Four Oaks Subdivision/R-PUD

Public Hearing

March 22, 2023

SHEET NO. **3.0**
 SCALE: AS NOTED
 JOB NO. **19-XX** REV.

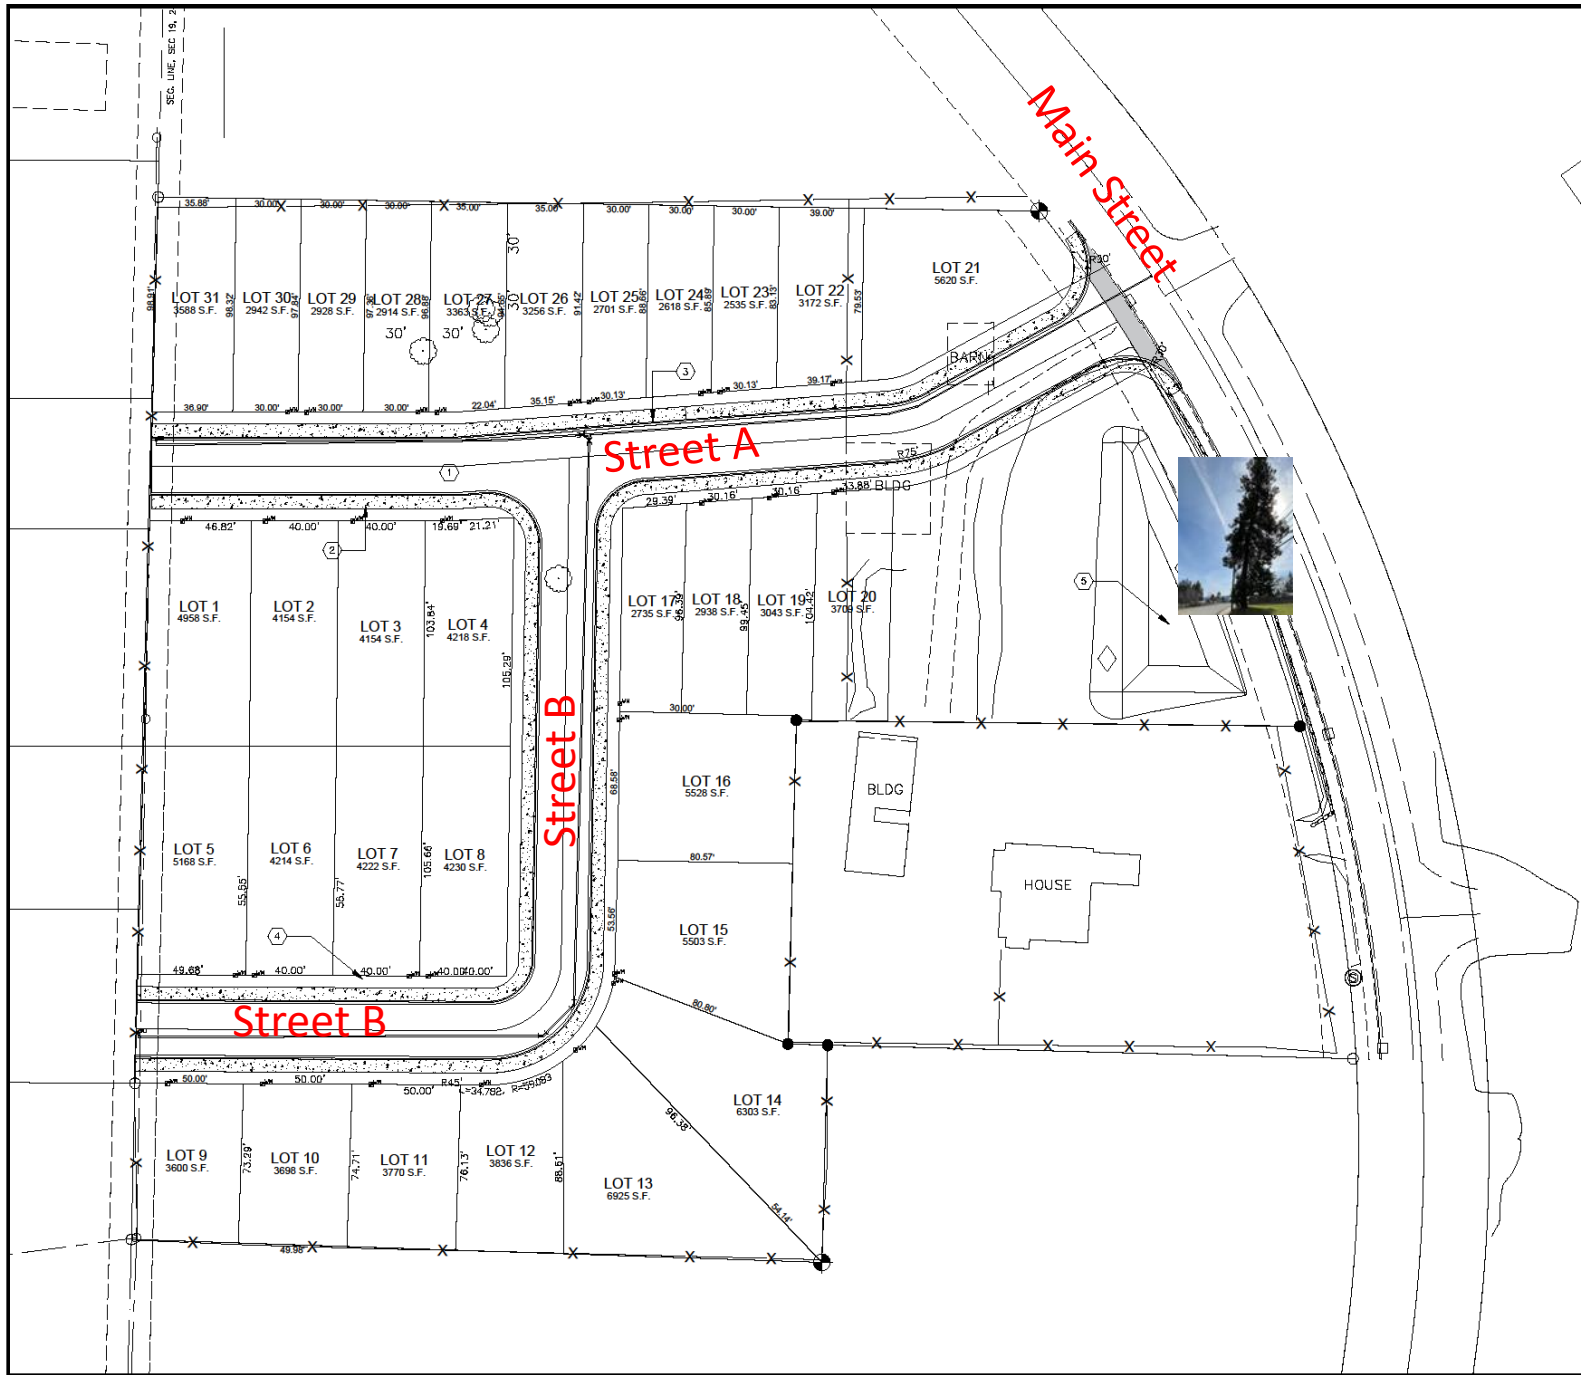
- Staff noted on-street parking was not part of plans

- A bioswale is included in open space. However, specific calculations were not included
 - Condition of approval:
Prior to final plat, Applicant shall provide stormwater plans to include capacity calculations and exact dimensions of the stormwater pond/bioswale.

Prior to final plat, Applicant shall provide plans that either allows for on-street parking or provides plans for how additional off-street parking shall be provided in sufficient quantities where on-street parking would not be necessary. If no on-street parking is provided, Staff shall require additional off-street parking beyond what would normally be required.
